**SUBMISSION IN RESPONSE TO THE ACCC'S
CONSULTATION PAPER**

**IN RELATION TO THE AUSTRALIAN RAIL
TRACK CORPORATION'S PROPOSED
HUNTER VALLEY RAIL NETWORK ACCESS
UNDERTAKING**

25 October 2010

EXHIBIT B

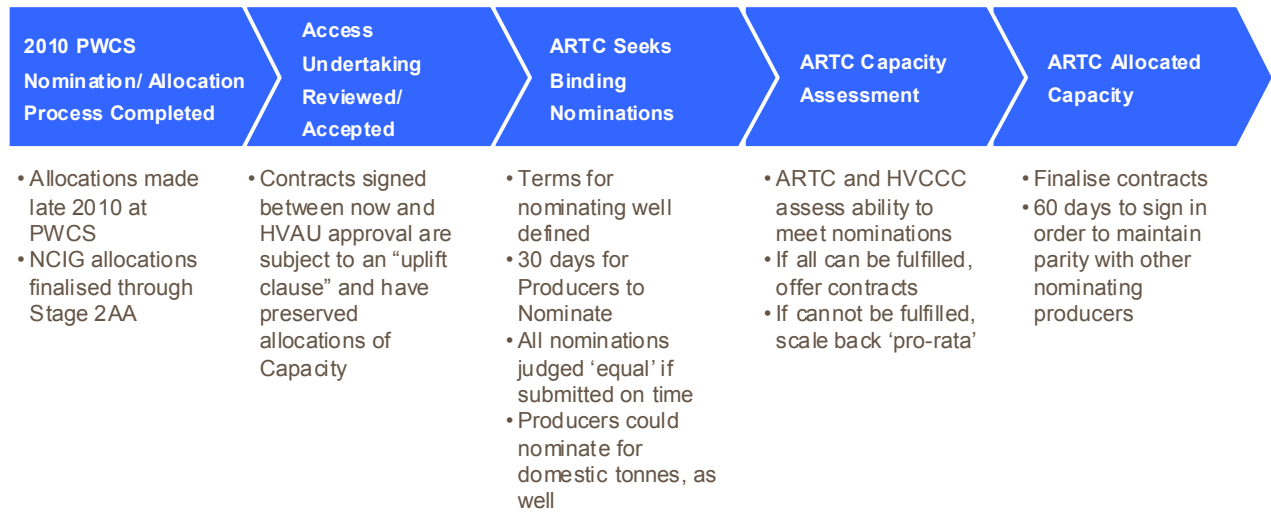
This methodology is consistent with the approach taken by ARTC in the 23 December 2009 draft IAHA that was circulated by ARTC to the industry, which contemplated the parties entering into the agreement before an HVAU was approved and which included an uplift clause (clause 19.1 of 23 December 2009 draft IAHA). C&A considers this approach appropriate given that ARTC has lodged an access undertaking application with the ACCC and, therefore, ARTC and Access Seekers should start planning towards the acceptance and implementation of an HVAU.

EXHIBIT C: Annual¹ ARTC Nomination, Track Investment and Contracting Framework

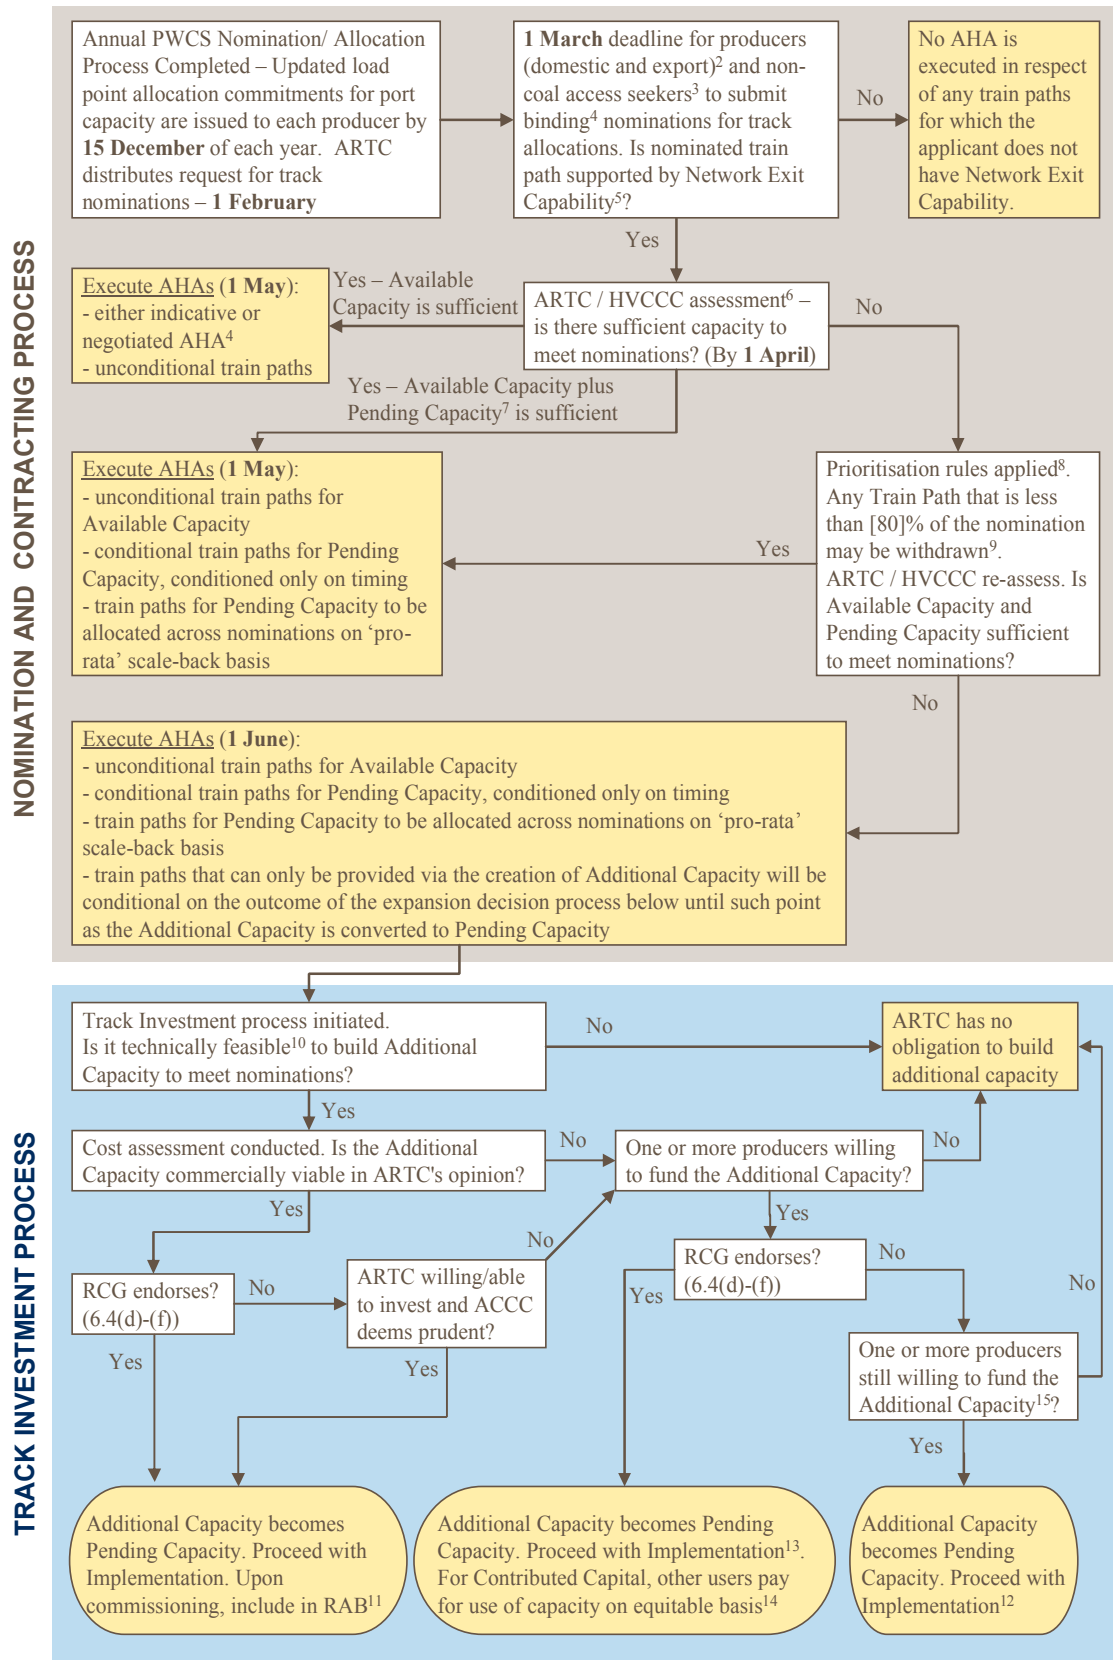
In place of the approach provided for in the Proposed HVAU, C&A proposes a Nomination, Track Investment and Contracting Framework that addresses the concerns that are raised above. The proposed Framework is described in detail in Exhibit C at the end of this section of this submission with a diagrammatic flowchart with footnote annotations on the various steps of the flowchart. Following the annotations is a summary of the differences between the approach provided for in

- (a) Nominations for Capacity will be made on an annual basis, with all nominations for Path Usages to be submitted within the same month each year, shortly after PWCS port allocations have been confirmed. Non-coal Access Seekers would nominate to the extent not already contracted. ARTC and HVCCC would then conduct the Capacity Analysis to determine whether existing and planned Capacity is sufficient to meet the track nominations, and whether additional capacity is required. Priority would be preserved for passenger Trains.

- (e) HVCCC can recommend the construction of Additional Capacity at any time, whether in conjunction with or outside of the annual Nomination, Track Investment and Contracting Framework.

1. **Annual process** – C&A suggests that the capacity nomination and allocation arrangements developed at PWCS provide an excellent basis for developing fair, transparent transitional arrangements on the track and could be adapted to consider other non-coal users of the Network. The nomination and allocation process at PWCS is an annual process, through which producers submit binding nominations for capacity at the port. PWCS only allocates and enters into contracts for long-term capacity through this process and the PWCS terminal access protocol includes a detailed set of allocation rules regarding the timing for the annual nomination process, the renewal of existing allocations, the Capacity Analysis and the objective criteria by which allocation is prioritised in circumstances where nominations exceed available capacity.

C&A is of the view that conducting an annual track nomination process, with coal export Access Holders being required to demonstrate the outcome of their port allocations as Network Exit Capability, and with binding nominations, would provide ARTC with a better platform for obtaining realistic, accurate nominations from Access Holders and Access Seekers.

From the perspective of achieving contractual alignment, an annual track nomination process that follows shortly after PWCS port allocations are issued, would provide a level of certainty that is lacking from the process provided for in the Proposed HVAU of ad-hoc contracting and Capacity Analysis as and when Applicants approach ARTC to negotiate an AHA. Without comprehensive, accurate nominations, there are necessary limits to ARTC's ability to conduct a meaningful Capacity Analysis. Further, without a firm Network Exit Capability requirement – that is, one that precludes an Applicant from obtaining Capacity Entitlements without demonstrating Network Exit Capability – , it is also difficult to understand how ARTC can have a meaningful understanding of how much Capacity on the Network is actually required in order to satisfy the Access Application (see note 4 below).

2. **Domestic coal** – C&A believes the track Capacity for domestic coal exit points can also be appropriately nominated for and allocated on an annual basis. To the extent that an Applicant wishes to secure track Capacity outside of the annual process, ARTC could enter into short term contracts (of less than one year) to provide Capacity until the subsequent annual nomination process, when the Applicant could nominate in the usual manner for a long-term Capacity Entitlements.

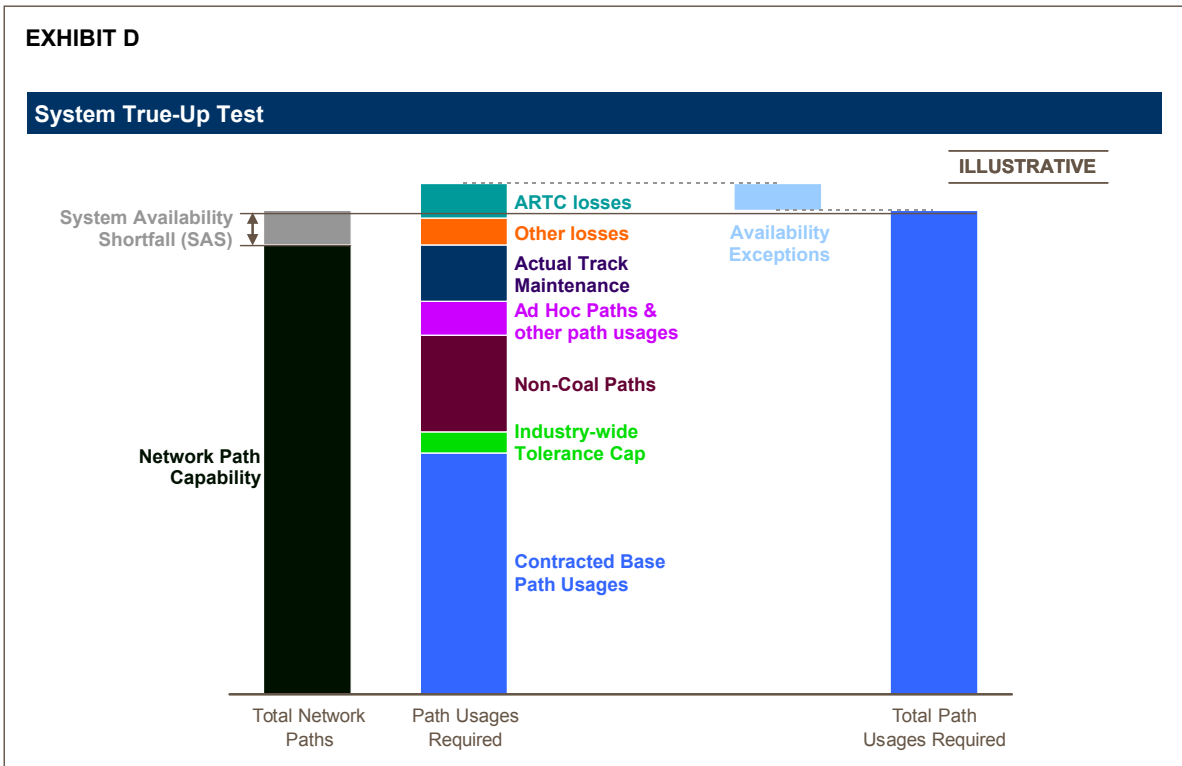
- (a) "Such an approach would involve complex judgements as to how planned capacity losses (for example, planned maintenance outages or system losses) should be allocated..."

C&A notes that the definition of NPC does not consider the impact of planned capacity losses as these are taken into account in the build up of TPR (that is, in the "actual maintenance requirement", the "actual ARTC system losses" and the "lesser of actual versus forecast other party system losses" terms). Hence, C&A queries why this is relevant to the determination of NPC.

- (b) "... and the adoption of arbitrary assumptions given the multiplicity of sources and sinks for coal traffic."

C&A's view is that ARTC can adopt the approach taken by the HVCCC and use its knowledge of which track contracts are in place and other production forecasts to ascertain the likely demand profile on the Hunter Valley rail Network.

Proposed Solution

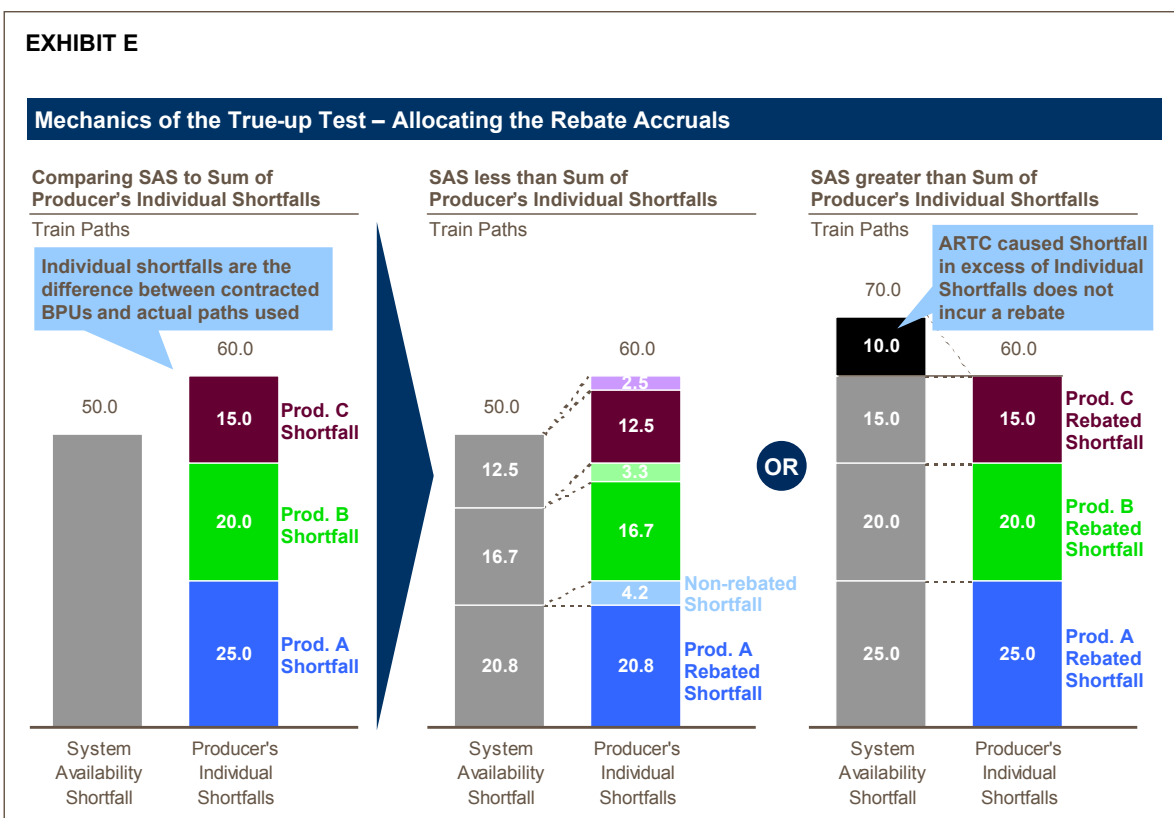
C&A is concerned that the definition of "TMTC" currently gives ARTC the discretion to set the TMTC at any level, although not greater than 10%, only having regard to consultations with the RCG (but not requiring RCG approval). C&A notes that it is possible for ARTC to set the TMTC at a level that is less than the industry's requirements (even to a zero level) which would impact on the flexibility needed in the Coal Chain. Therefore, C&A believes it is appropriate to set a minimum TMTC, and require ARTC to seek approval from the RCG in order to set the TMTC below this level.

C&A proposes that the definition of TMTC be amended to include a minimum level of TMTC and a requirement that any decisions to set TMTC below this level must be approved by the RCG.

EXHIBIT L

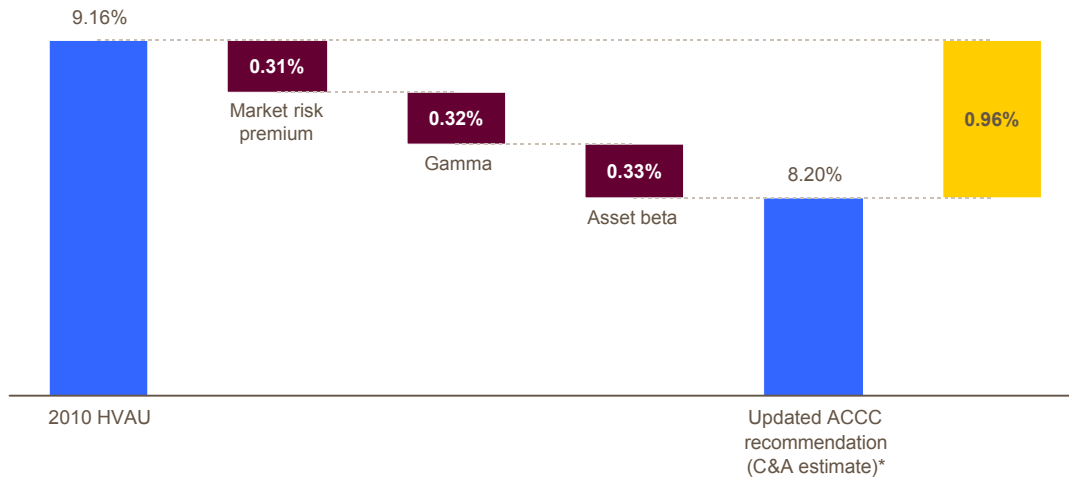
Comparing the impact of market risk premium, gamma and asset beta (as proposed in the ACCC's Draft Decision and adjusted for current market conditions) to ARTC's proposed input parameters (see Appendix 3 of the Explanatory Guide), the difference in WACC is approximately 100 basis points (see Exhibit L below).
